DESIGN REVIEW & PRESERVATION BOARD

APPLICANT	Luckey Construction, 2111 W. Shaw Avenue, Fresno, CA 93711		
OWNER	Zubiri Venture, 1451 River Park Drive, Suite 110, Sacramento, CA 95815		
PLANS BY	The Spink Corporation, P.O. Box 2511, Sacramento, CA 95811		
FILING DATE	November 14, 1983	REPORT BY:	RBH:mm
NEGATIVE DEC.	N/A	EIR	ASSESSOR'S PCL. NO. 225-240-43 and 51

PROPOSAL: Project review of 215 condominium units.

DR 83-184

**BUILDING LAYOUT PLAN**

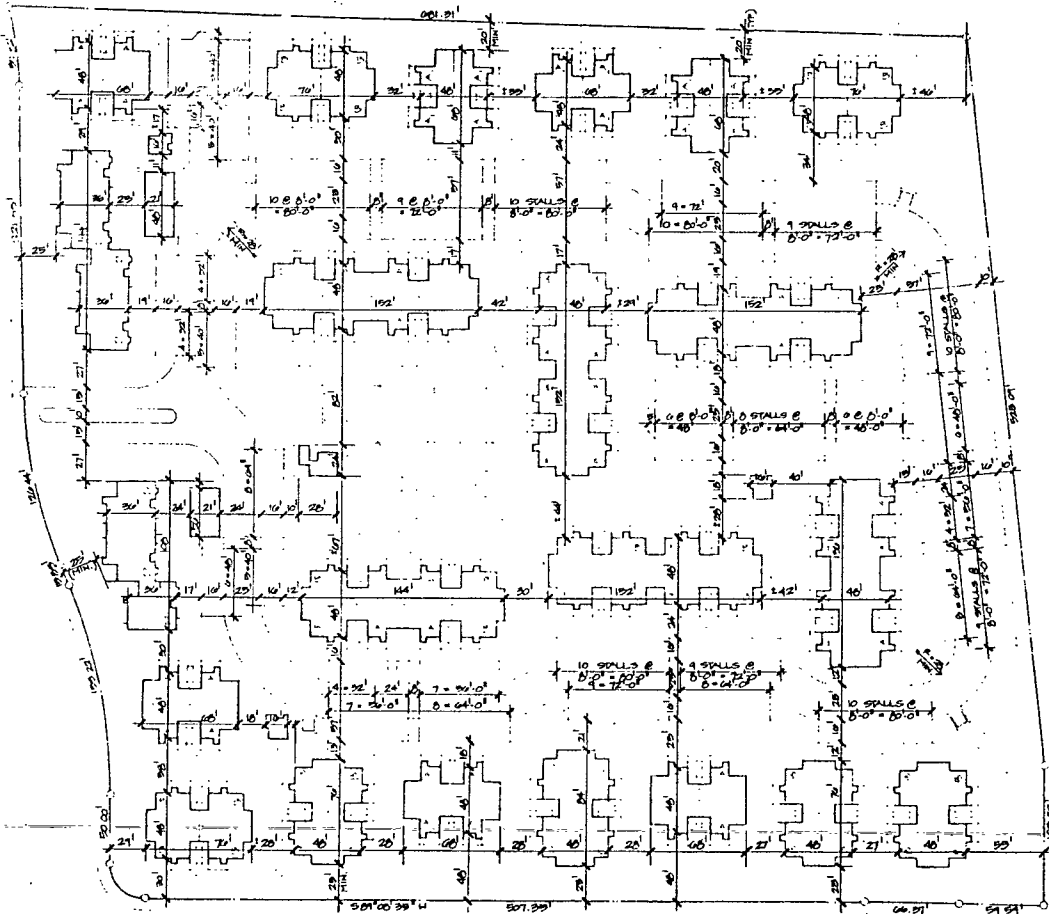
1. The architectural design of the residential units appear to staff to be well designed and do not require any additional modifications.
2. The site plan shows only four locations for trash storage. Staff feels because of the density of the project, additional trash storage locations should be provided.
3. The residential design criteria for the project shall be followed throughout in the design and completion of the units. (See Exhibit G).

1. The applicant shall provide additional trash storage units in order to meet the density requirements of the project.
2. The applicant shall utilize the residential design criteria (Exhibit G) in the development of the project.
